Macklin Street 23 pre-app

Request for Pre-application Advice

23 MACKLIN STREET, LONDON

6.1 English Heritage & Camden Council Site Meeting

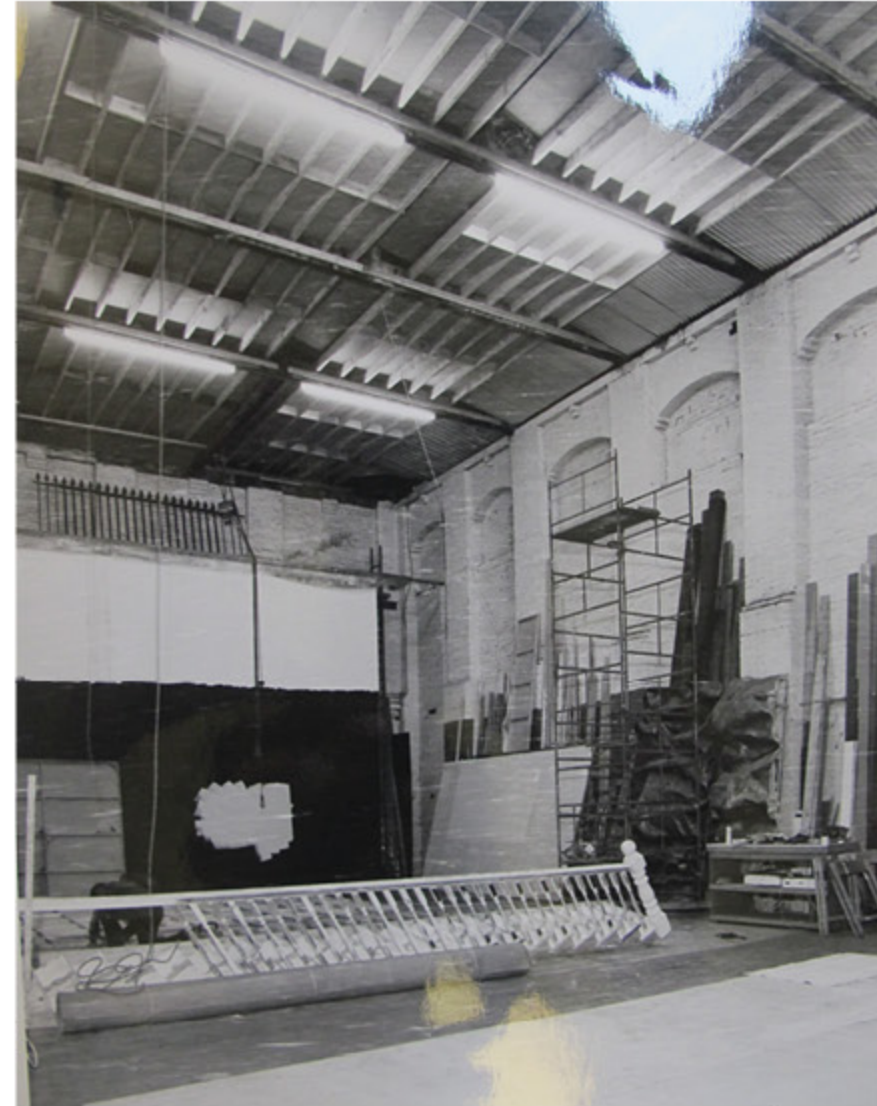
The photographs included on this page were supplied by Mark Price from Theatres Trust on 01 November 2013 following an on site meeting and walk-around on 24 October 2013. The photograph of the facade supports the proposal as stated by Mark Price's support for the proposed scheme "Certainly the six pane windows, and the central arch proportion being over two floors"

The historic photographs of the interior give evidence of the gap used for the movement of the paintframes. The photos also provide evidence that there was an internal wall and floor on the ground floor level historically.
